**SAN LORENZO VALLEY WATER DISTRICT
CROSS COUNTRY PIPELINE CONSTRUCTABILITY
PEER REVIEW OF FREYER & LAURETA STUDY AND MEMO**

**Peer Review of March 2022 Study and
Draft Supplemental Evaluation Dated April 6, 2022**

24 NOVEMBER 2022
PROJECT NO. 12196

FIGURE 1A
 PROJECT: 12196
 Date: 10/24/2022

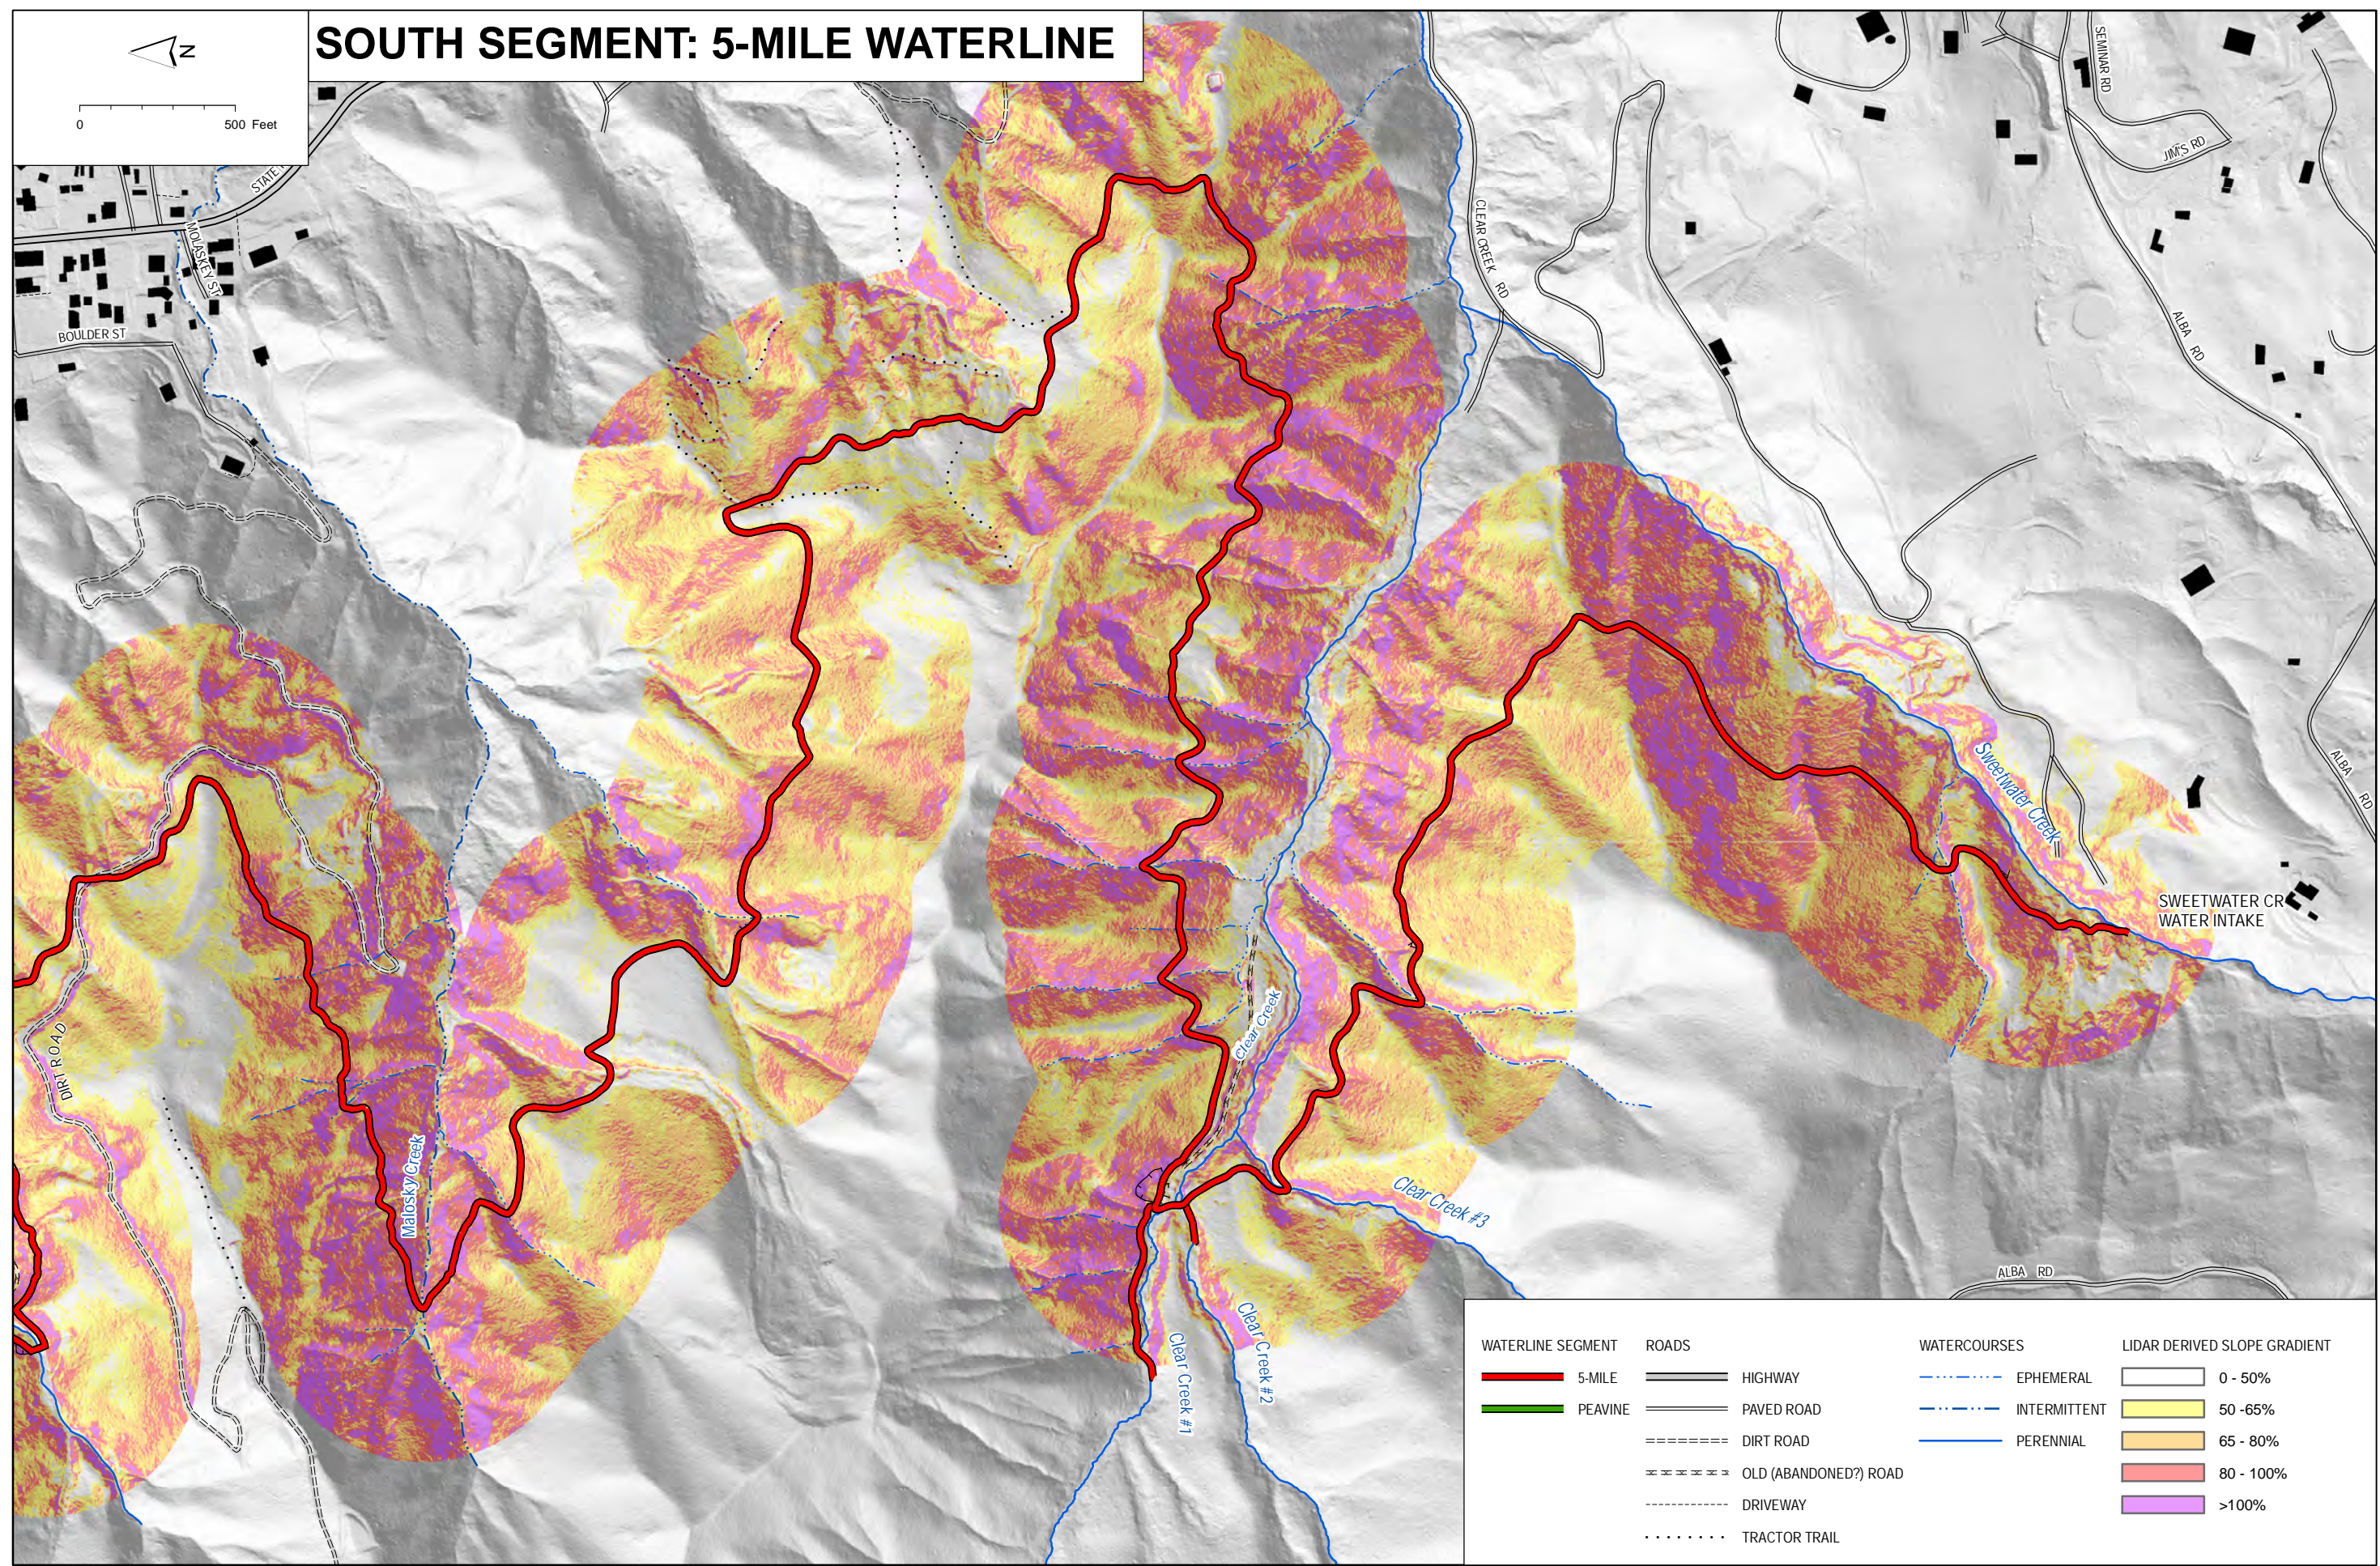
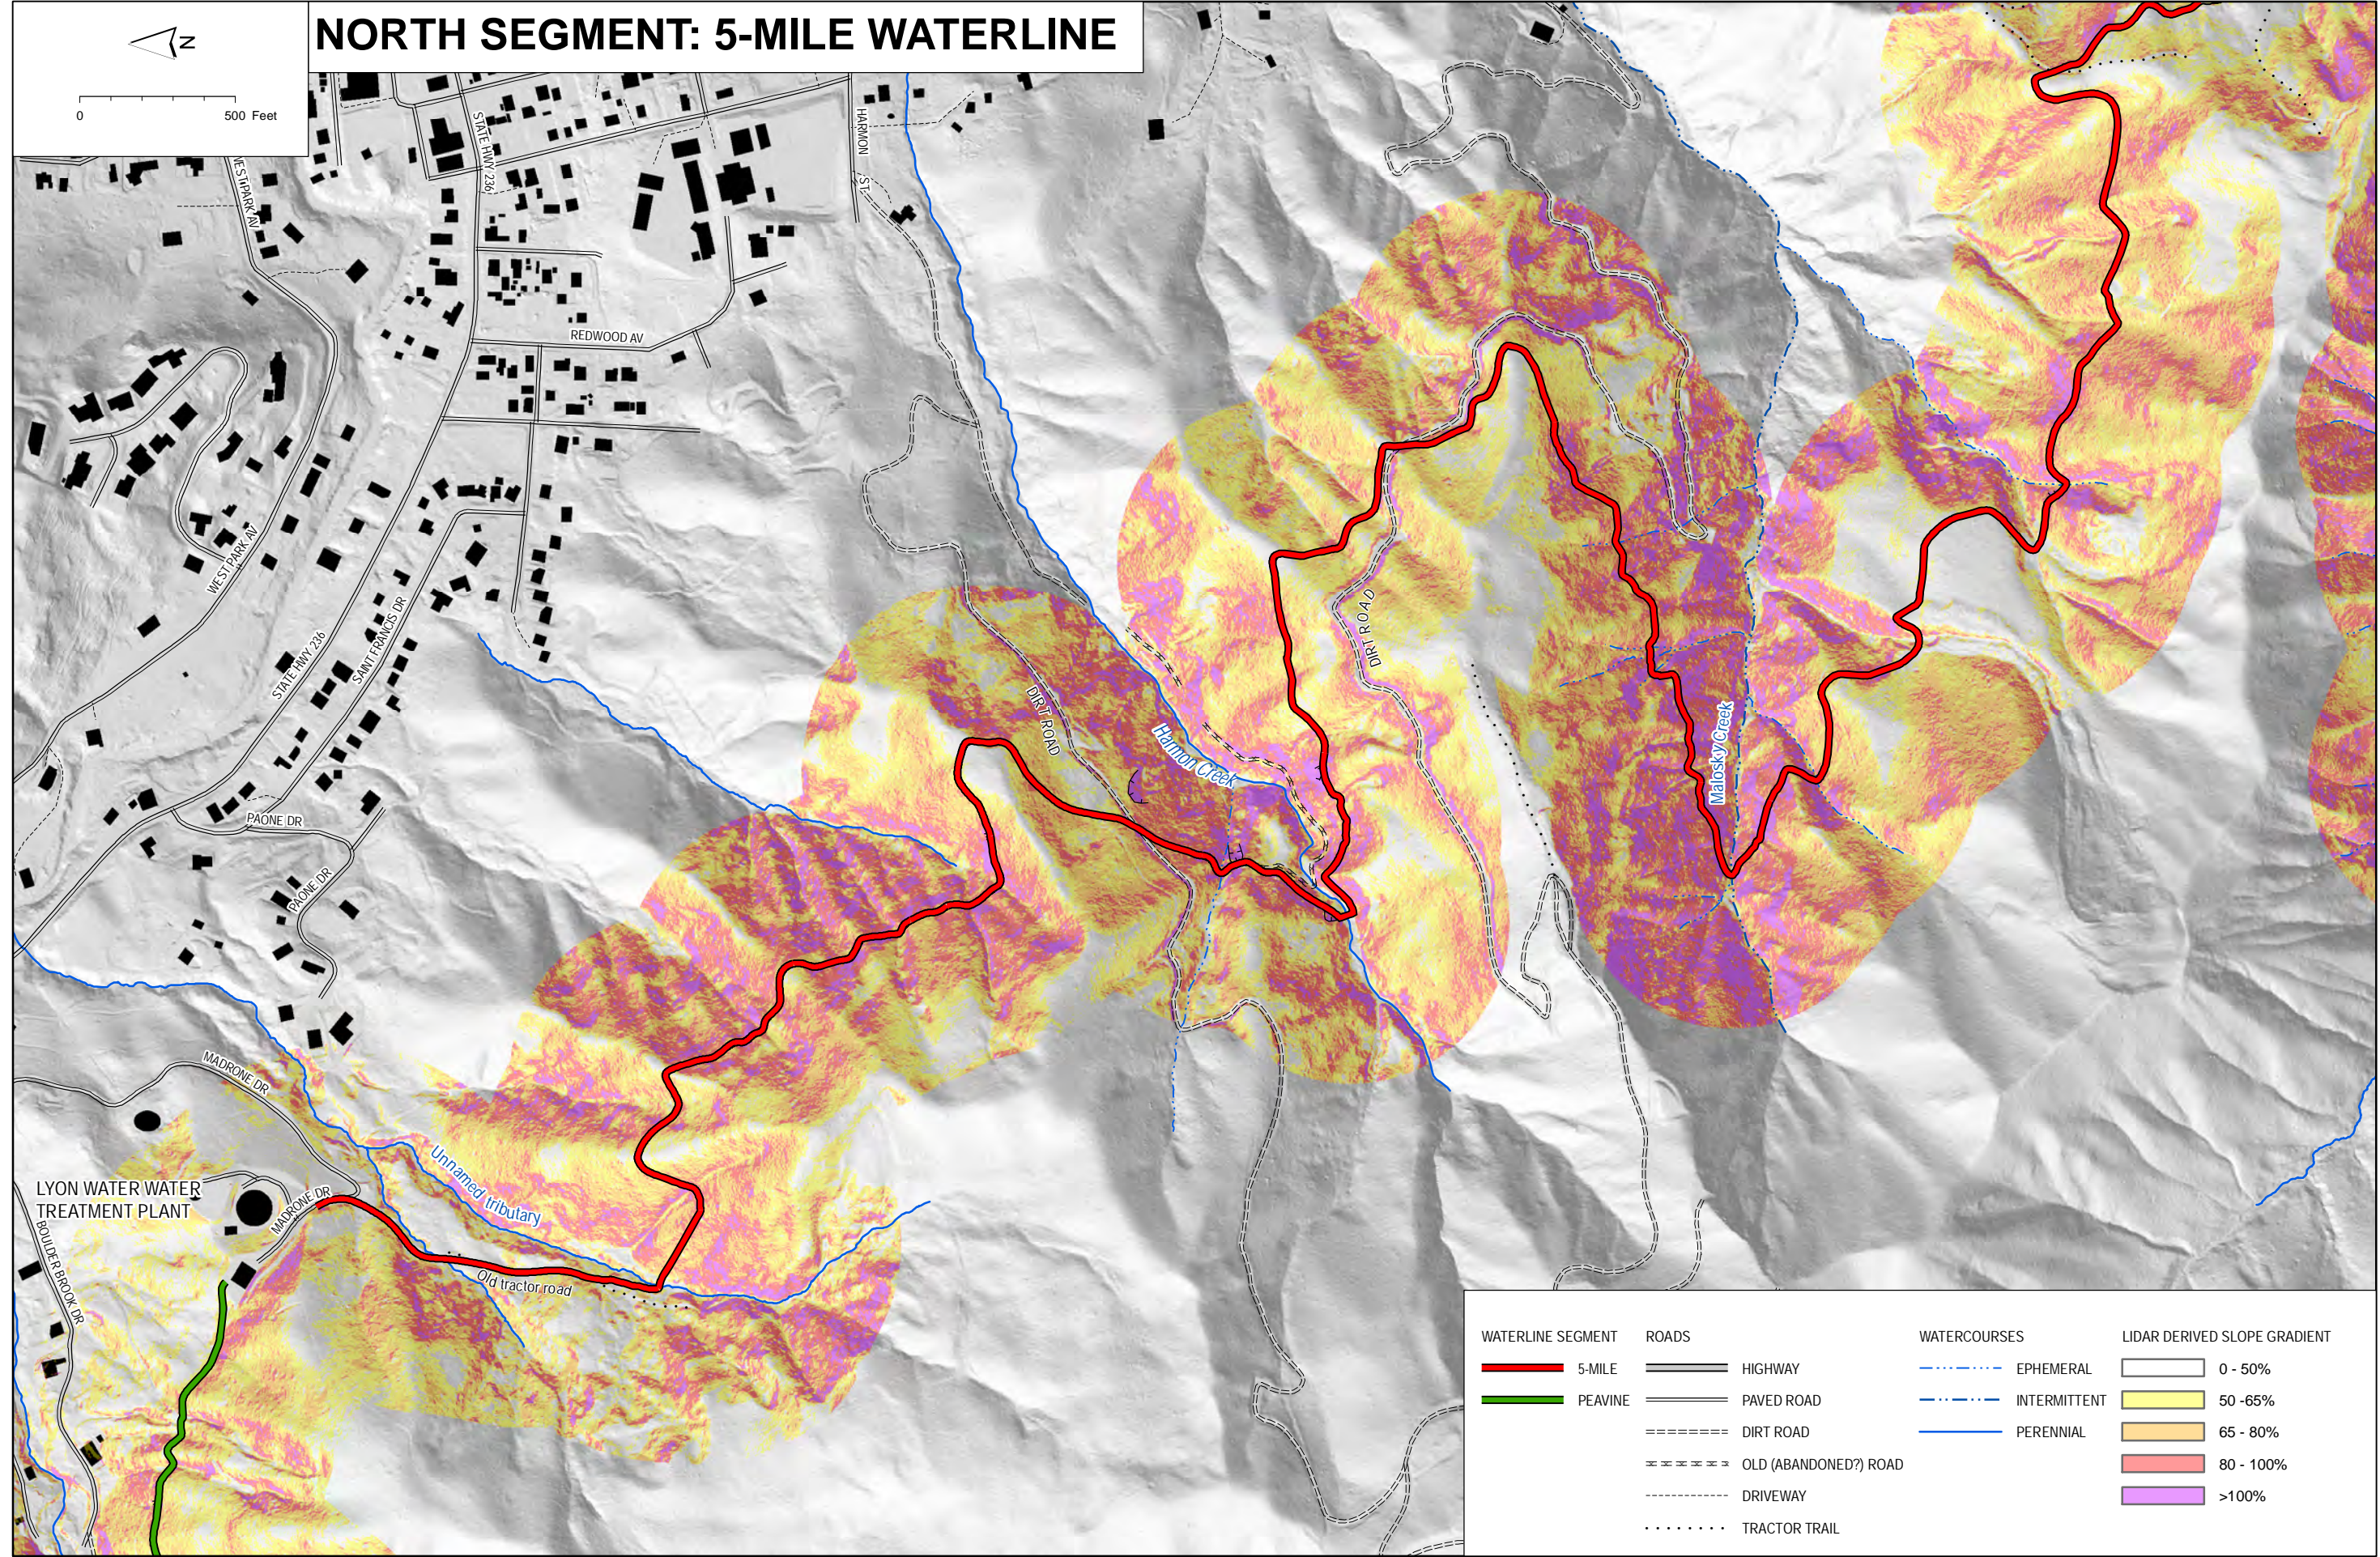
To further evaluate topographic conditions along the alignment, the HKA team generated a slope map of the project area based on a GIS analysis of the 2020 Santa Cruz County, CA LiDAR-derived bare earth digital elevation model (DEM)(NOAA, 2020) coupled with field observations. LiDAR (Light Detecting And Ranging) is a technology that uses lasers to determine the distance to surfaces or objects and can be used to generate relatively accurate measurements of ground elevation. The results were filtered to removal small areas less than 1,000 square feet that were either steeper or gentler than the surrounding ground and which, in our opinion, is generally not representative of the larger average site conditions. The slope map generated for the project area is depicted in Figure 1.

Our LiDAR analysis (See Figure 1A, B and C in Appendix A and Table 1 on Page 20) and the field reconnaissance suggests that about 87% of the alignment is adjacent to slopes steeper than 50% = 2:1(H:V). This difference corresponds to approximately 13,000 feet (lf) of additional alignment that may require retaining structures. Using the F&L unit price cost estimate of \$700/lf, an additional 37%
